# UNITED STATES PATENT AND TRADEMARK OFFICE

APPLICATION NO.	FILING DATE	FIRST NAMED INVENTOR	ATTORNEY DOCKET NO.	CONFIRMATION NO.
10/518,435	07/01/2005	Christophe Ripoll	262367US2XPCT	7951
22850	7590	12/30/2005	EXAMINER	
OBLON, SPIVAK, MCCLELLAND, MAIER & NEUSTADT, P.C.			ROSENAU, DEREK JOHN	
1940 DUKE STREET			ART UNIT	PAPER NUMBER
ALEXANDRIA, VA 22314			2834

<b>Office Action Summary</b>	<b>Application No.</b>		<b>Applicant(s)</b>	
	10/518,435		RIPOLL, CHRISTOPHE	
	<b>Examiner</b>		<b>Art Unit</b>	
	Derek J. Rosenau		2834

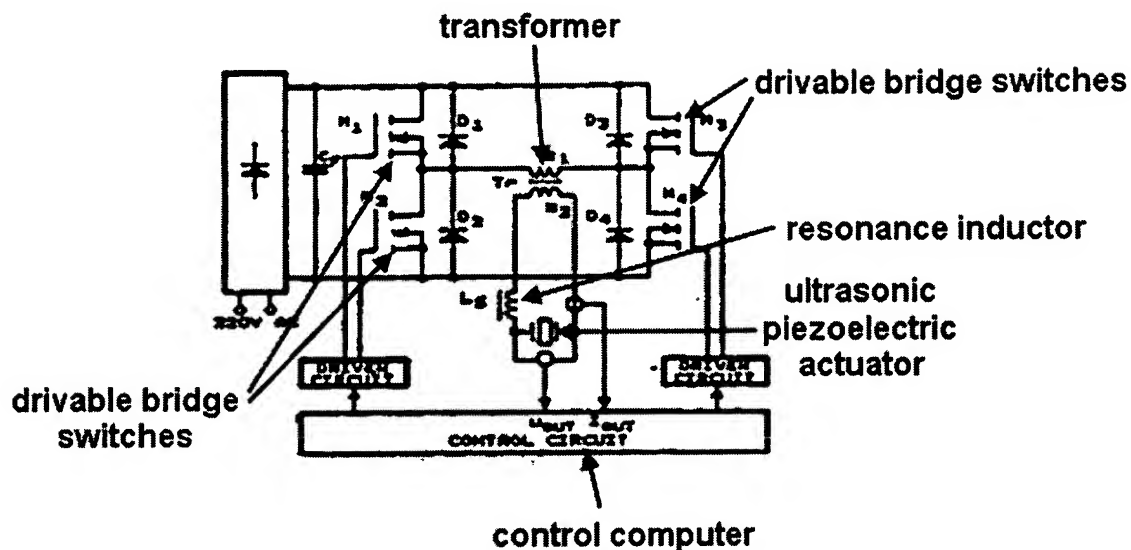
13. Fabijanski discloses a driving device for electronic activation with an ultrasonic piezoelectric actuator (see figure below), a control computer (see figure below), an actuator (see figure below, ultrasonic piezoelectric actuator), a resonance inductor (see figure below), drivable switches (see figure below), and a transformer (see figure below). There are four drivable bridge switches, with a first arm having two drivable bridge switches in series, a second arm in parallel with the first arm, and also is composed of two alternately drivable bridge switches.
